**Special Standard
PUD Zoning District**

Project Name: Mayberry Phase 2

PCD File No.: PUDSP251

DEVIATION REQUEST (Attach diagrams, figures, and other documentation to clarify request)

Mayberry Phase 2
El Paso County
PUD Development Plan & Preliminary Plan
Overall Site Plan

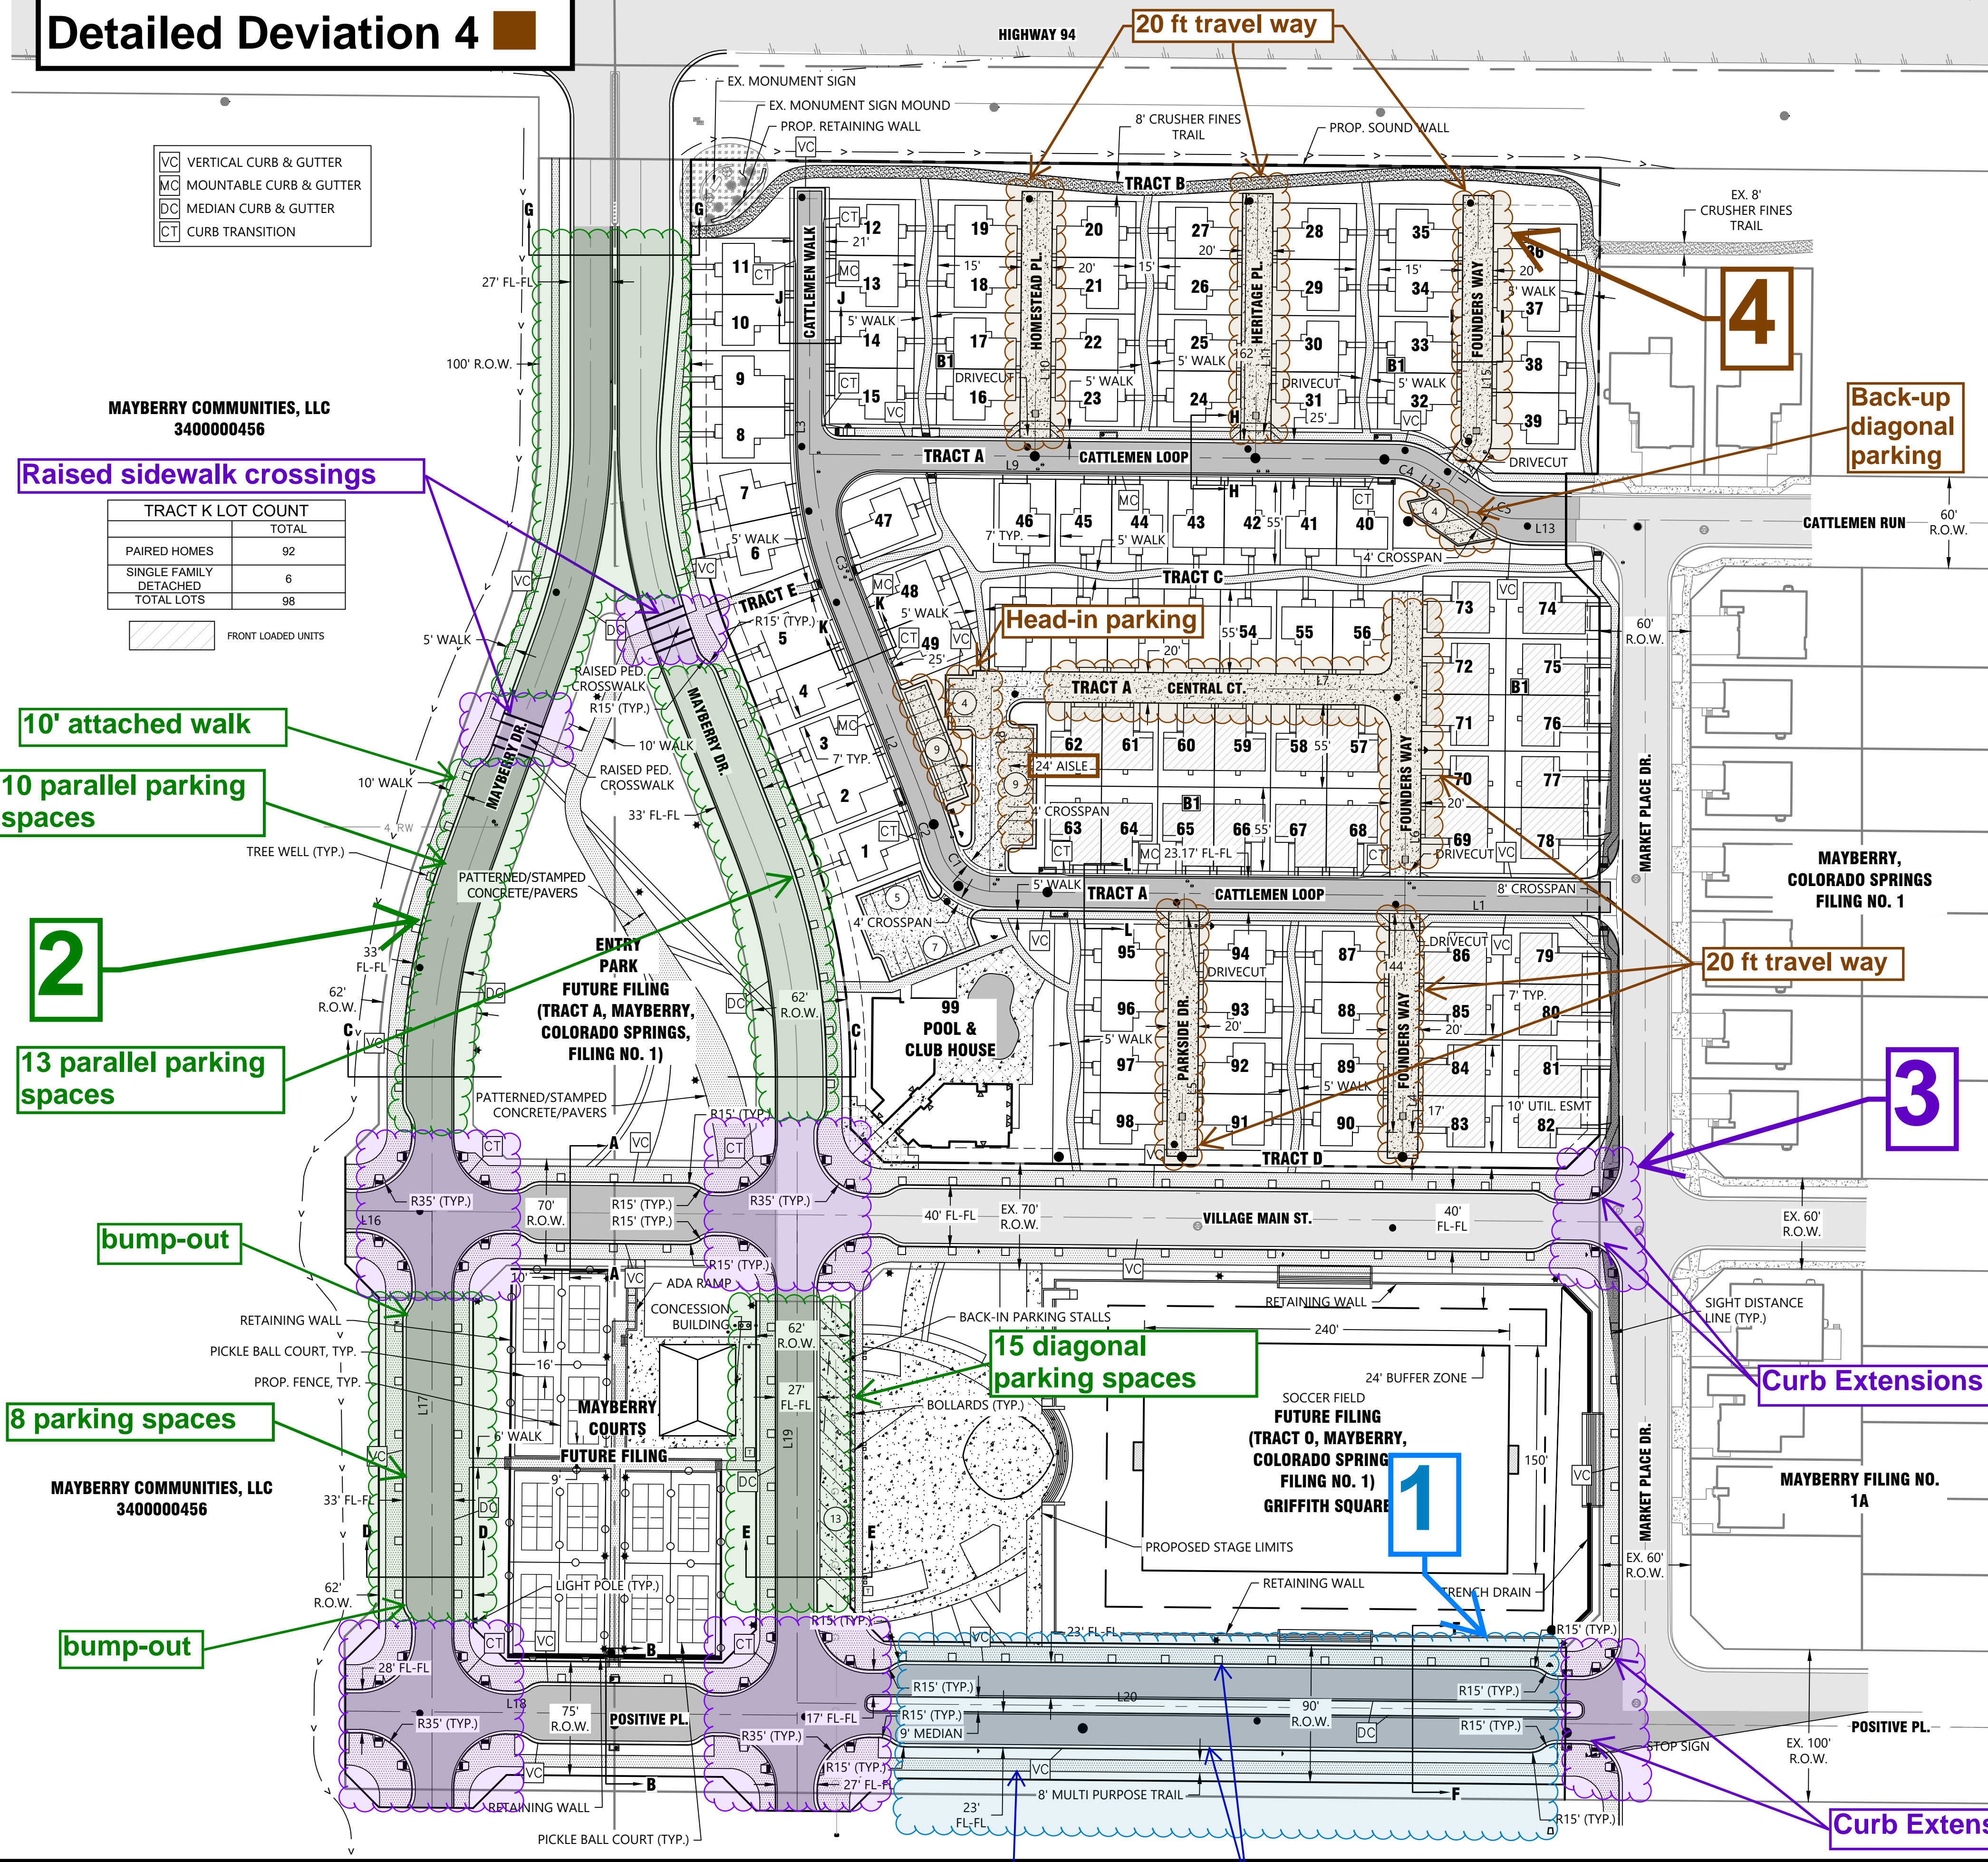
Raised sidewalk crossings

10' attached walk
10 parallel parking spaces

POSITIVE PLACE SECTION B-B
 75' R.O.W.
 DESIGN SPEED: 30 MPH
 (URBAN RESIDENTIAL COLLECTOR)
 SCALE: 1" = 5'

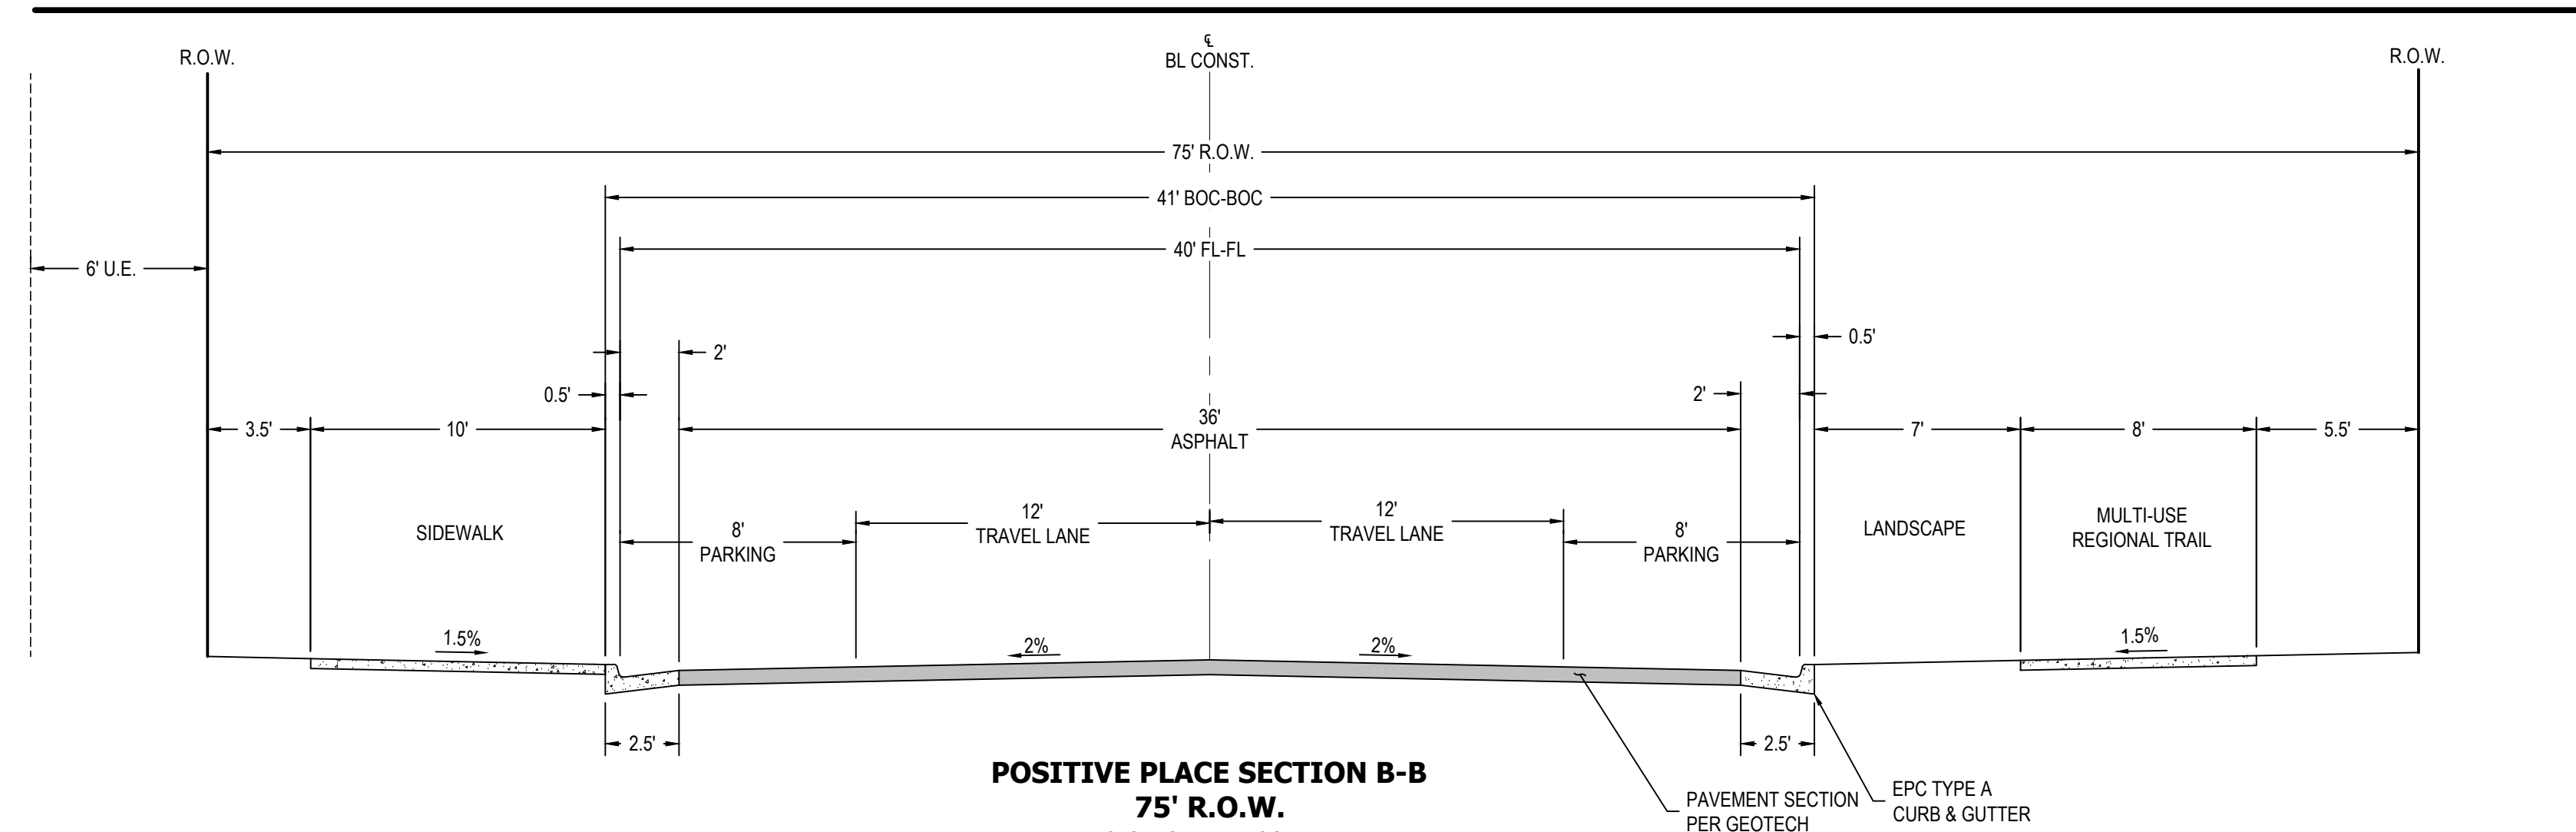
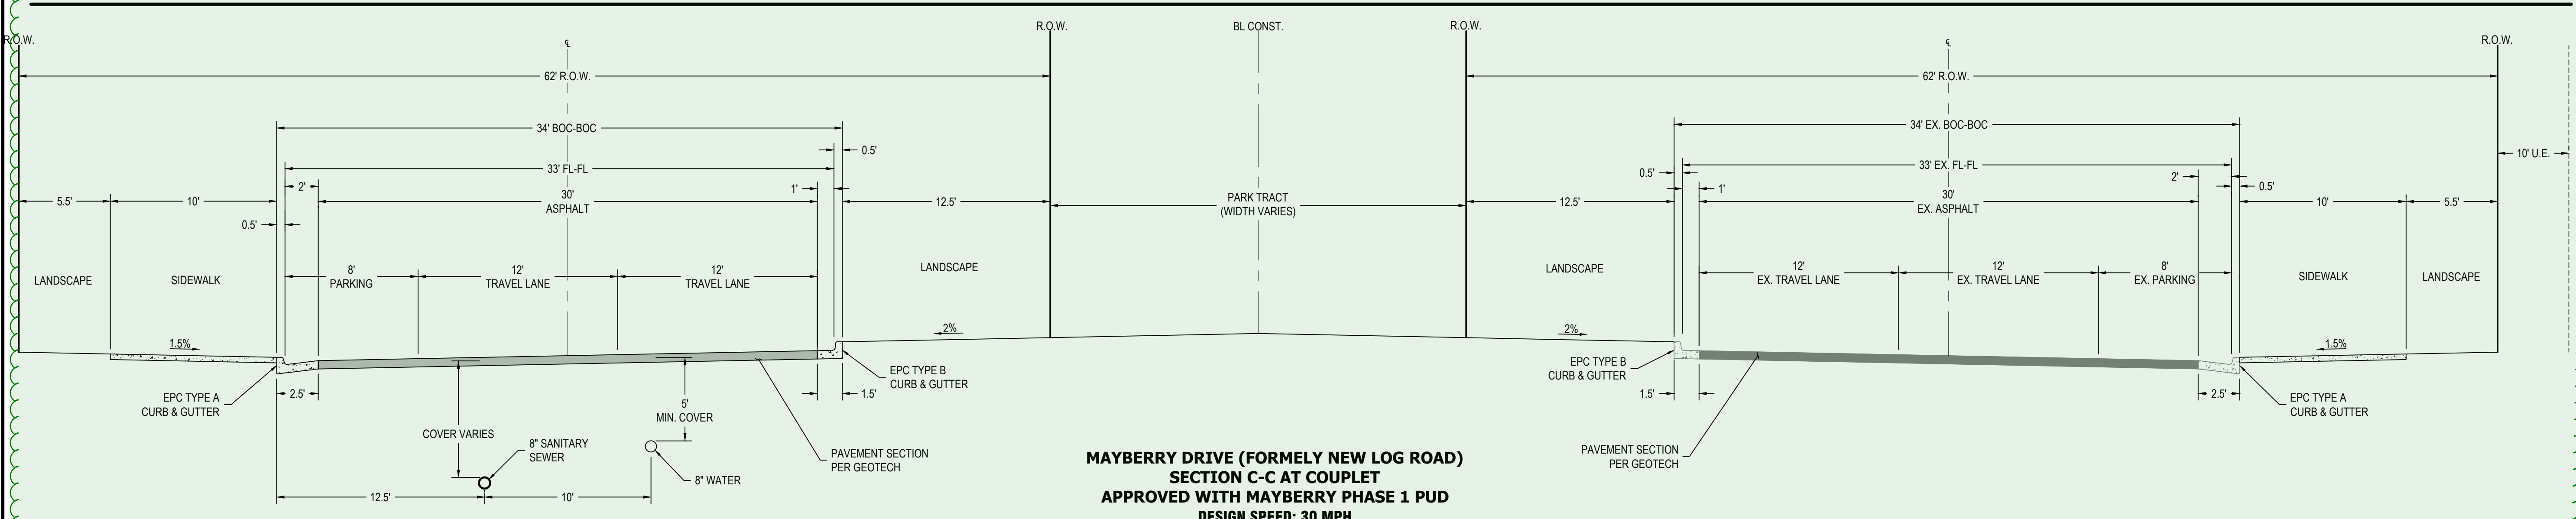
1. Reduction of Urban Residential Collector ROW Width (Positive Place)
 - From 100 feet (Mayberry Phase 1 standard) to 90 feet (proposed)
 - To accommodate a regional trail system, provide on-street parking, and reduce pedestrian crossing distances.
2. Modified Urban Minor Arterial Cross Section (Mayberry Drive)
 - Inclusion of a 10-foot attached sidewalk, and limited parallel and diagonal parking
 - To support pedestrian activity and adjacent community-oriented land uses.
3. Intersection Bump-Outs and raised sidewalk crossing on either side of the Mayberry Drive Couplet
 - To shorten pedestrian crossing distances and improve visibility and safety at intersections.
4. Private Roads within Tract K
 - To allow design flexibility and support internal circulation consistent with the planned development layout.

1. ROW Width Reduction (100 ft → 90 ft)

- 14-ft travel lanes
- 8-ft parking lanes

Mayberry Phase 2
El Paso County
PUD Development Plan & Preliminary Plan
Tract K Site Plan

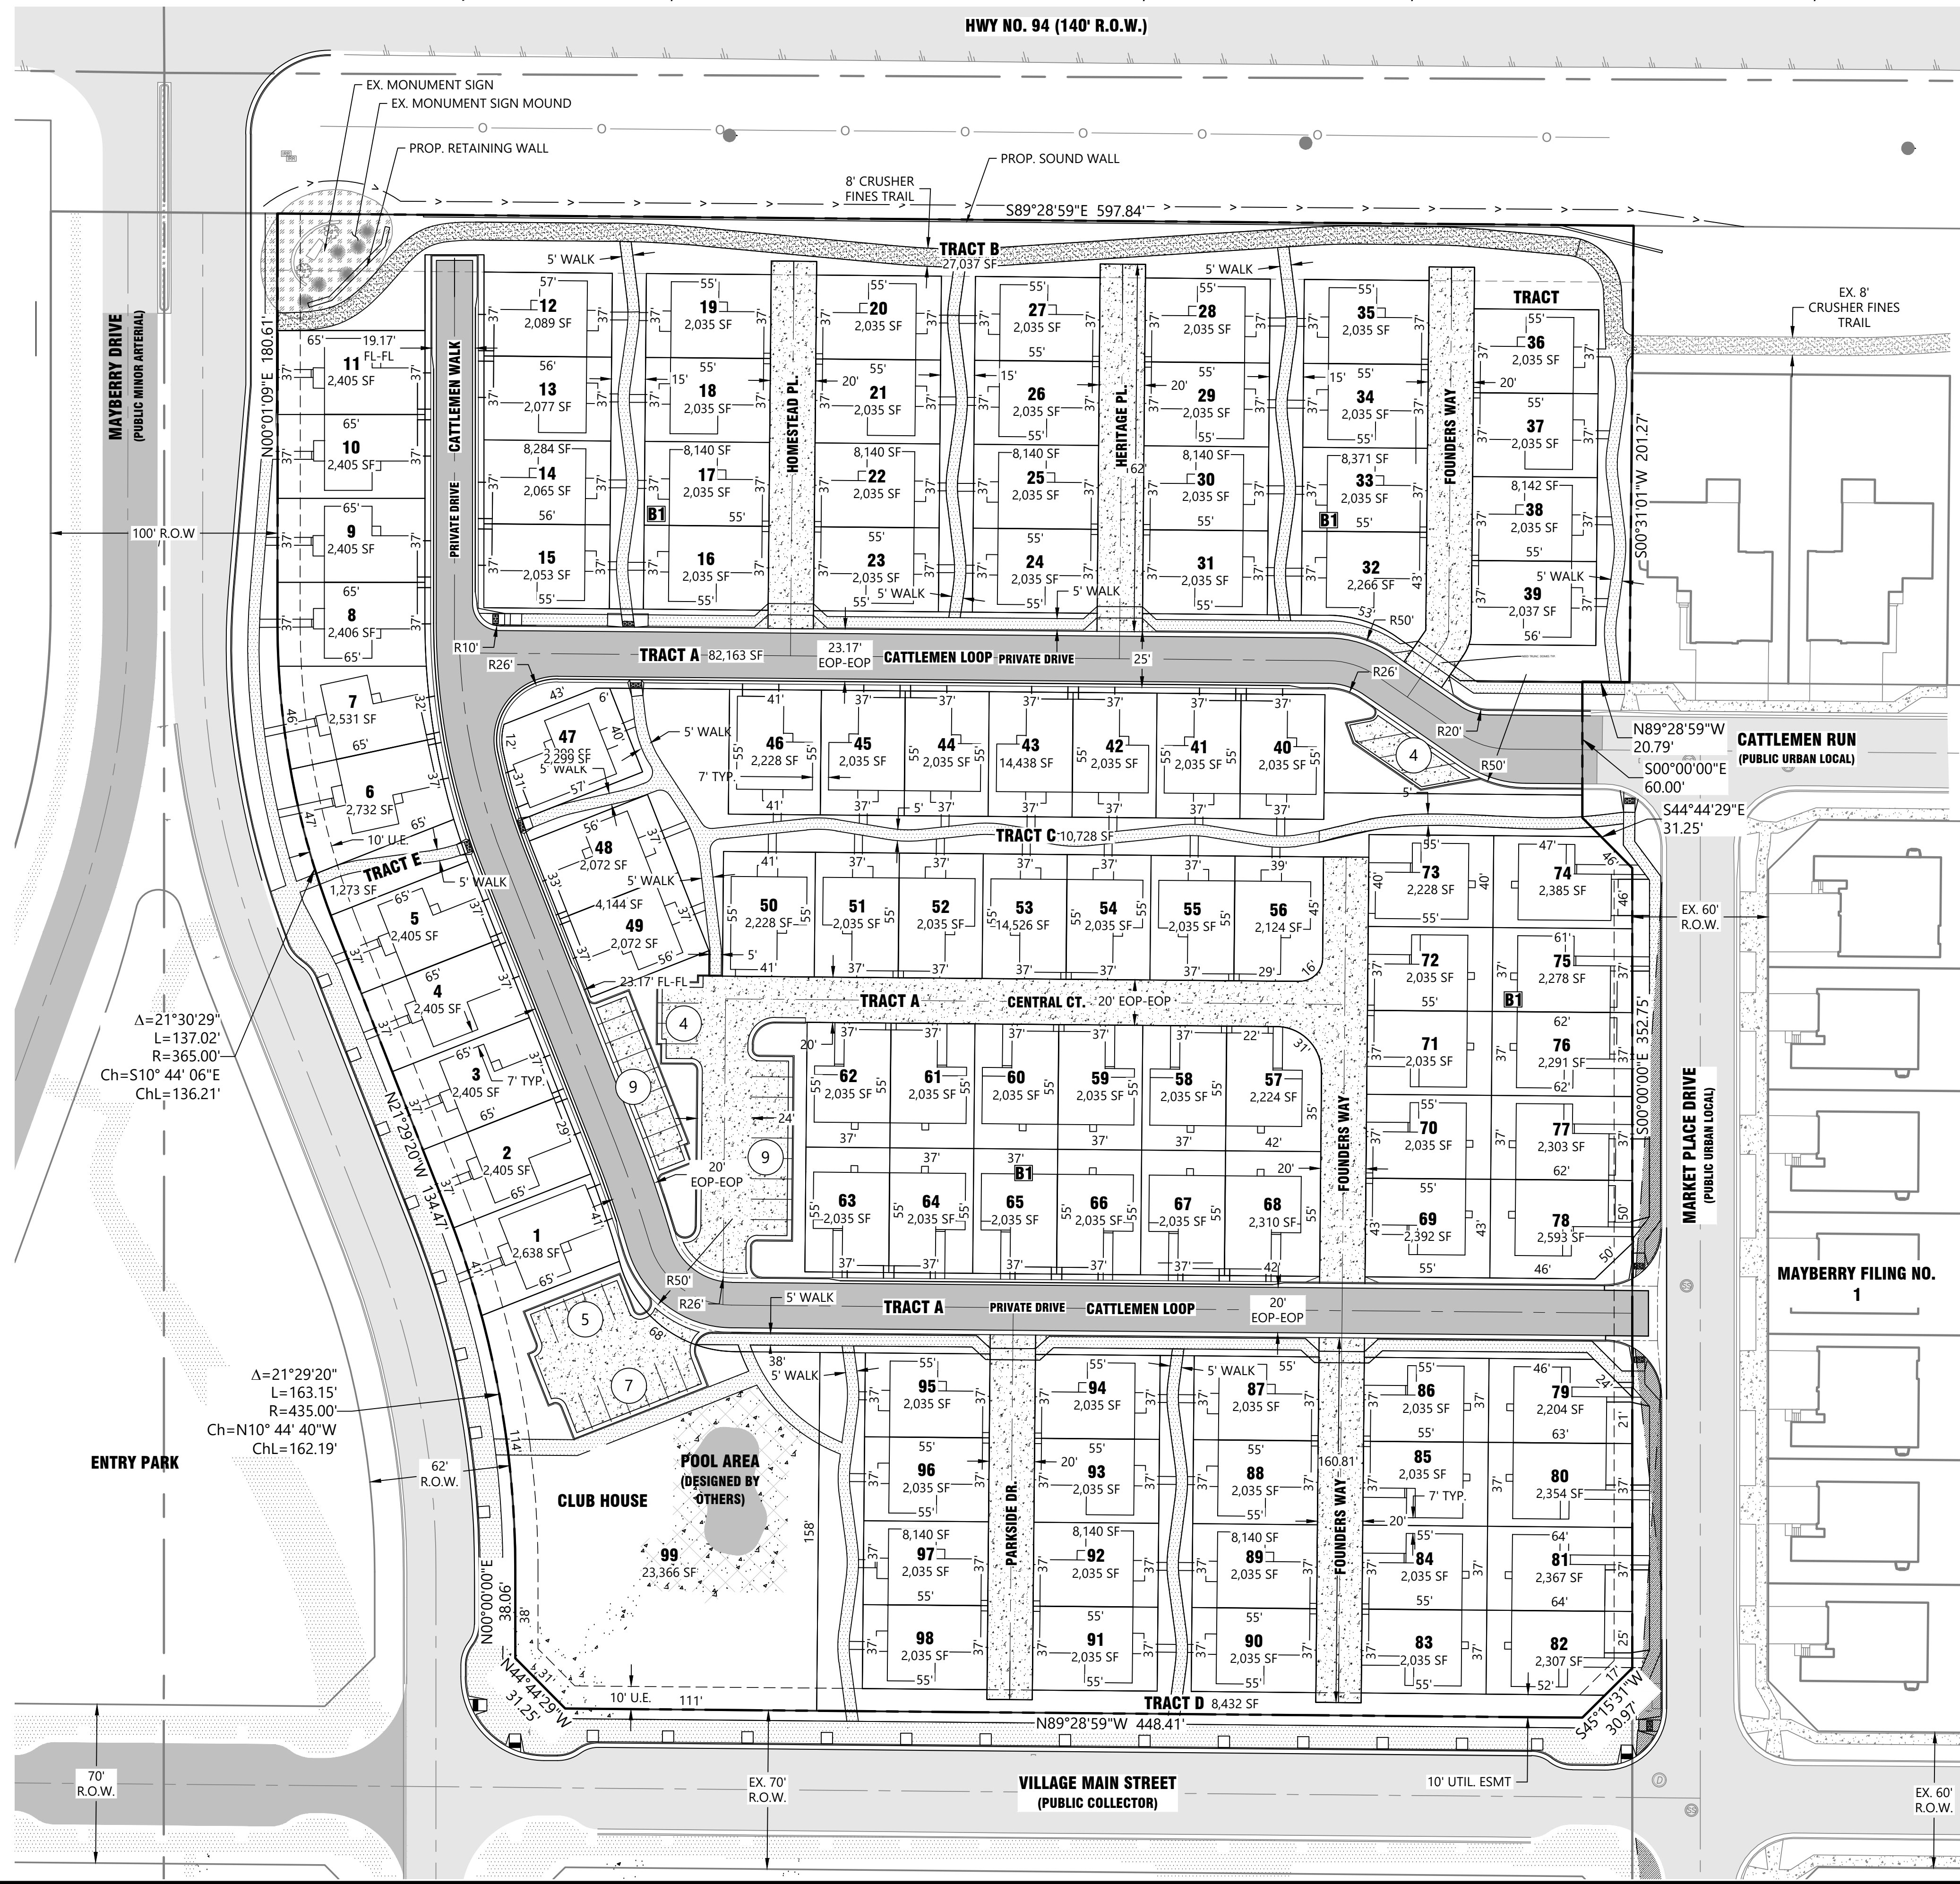
1. Reduced and Variable Roadway Widths
 - The proposed private road network within Tract K includes
 - Variable-width roadway sections ranging from approximately 21 feet to 25 feet (asphalt with mountable curb).

- Fire Department Coordination:
 - The Fire Department has reviewed the proposed roadway configuration and has confirmed that a 20-foot-wide travel way is acceptable for emergency access, provided that the roadway is designated as a fire lane.

- “NO PARKING – FIRE LANE” signage will be installed and maintained along these segments to show that the required clear width is preserved at all times for emergency vehicle access.
